Errata Sheet

October 16, 2001 / Release 1.5

Device:	SAK-C167CS-LM SAK-C167CS-4RM
Stepping Code / Marking:	ES-AB, AB
Package:	P-MQFP-144-1

PLL.3.4: Increased PLL Jitter caused by external Access

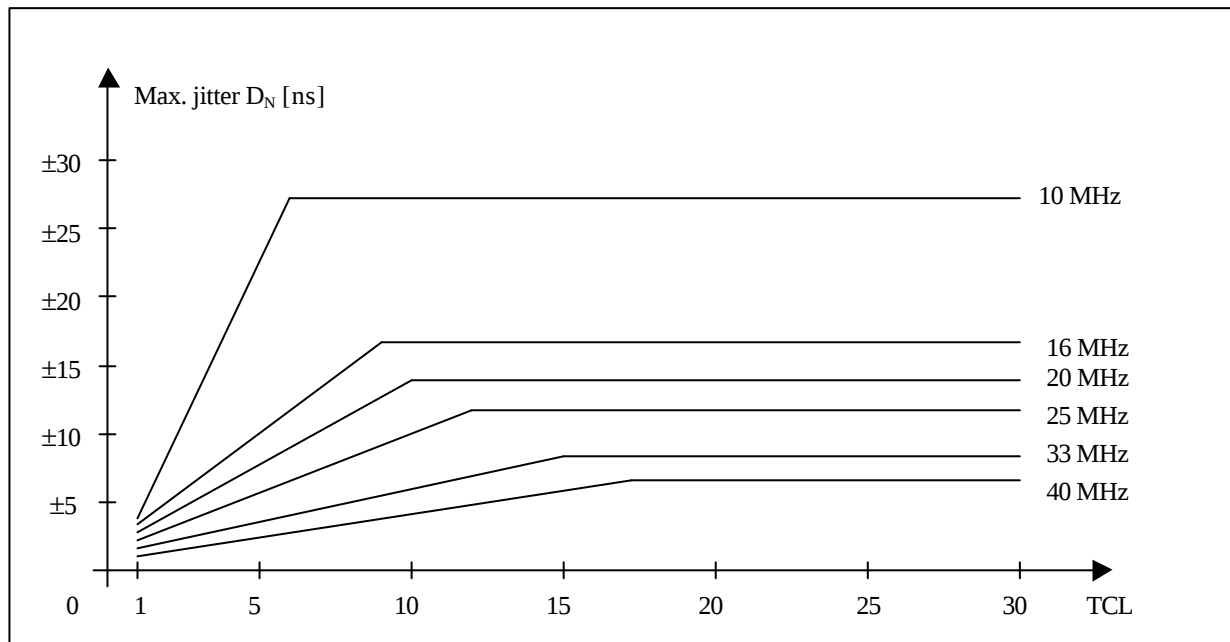
In systems where the PLL is used for generation of the CPU clock frequency, the PLL jitter can increase under certain circumstances and exceed the specified value.

The value of the additional jitter is not a fixed one but it depends on the kind of activity on the external bus or output pins. The additional jitter increases with the number of output/bus pins which are switched at the same time to a new voltage level because the problem is caused by noise on the on-chip power supply.

The capacitive load of the used pins has also an influence to the additional jitter. A high capacitive load can increase the additional jitter.

All PLL factors are affected (PLL factor 1.5 / 2 / 2.5 / 3 / 4 / 5). The PLL jitter increases when access to the external bus or output pins is performed. This phenomenon has no influence to direct drive-, prescaler-, and SDD mode.

The additional jitter has the maximum effect if only one TCL is considered (period jitter). This can have an influence to the bus timings with one TCL.

The additional jitter decreases with the number of consecutive TCLs (accumulated jitter). The accumulated jitter has an effect on timings with more than one TCL (certain bus timings, CAN bus timing, serial interface).

For an accumulated period of $N \cdot T_{CL}$ the new maximum jitter D_N [ns], which exceeds the specified value in the Data Sheet, is computed using the formula:

$$D_N[\text{ns}] = \pm((260 / f_{\text{CPU}} + 100 / f_{\text{CPU}}^2) * (N / T_m) + 0.2)$$

Where N = number of consecutive T_{CL} , f_{CPU} = CPU frequency in MHz and $T_m = f_{\text{CPU}} * 0.35 + 2.5$.
This approximated formula is valid for a CPU frequency $10 \text{ MHz} \leq f_{\text{CPU}} \leq 40 \text{ MHz}$ with the conditions:

$$\begin{aligned} T_m &= f_{\text{CPU}} * 0.35 + 2.5 & \text{for } N \leq T_m \\ T_m &= N & \text{for } N > T_m \end{aligned}$$

In the case that the additional jitter causes problems in the system which cannot be relaxed with software adapted timing parameters the following workarounds are possible:

- If the clock generation is done with the on-chip oscillator then direct drive- or prescaler mode can be used.
- If the maximum frequency of the on-chip oscillator is not sufficient then an external clock generator can be used.
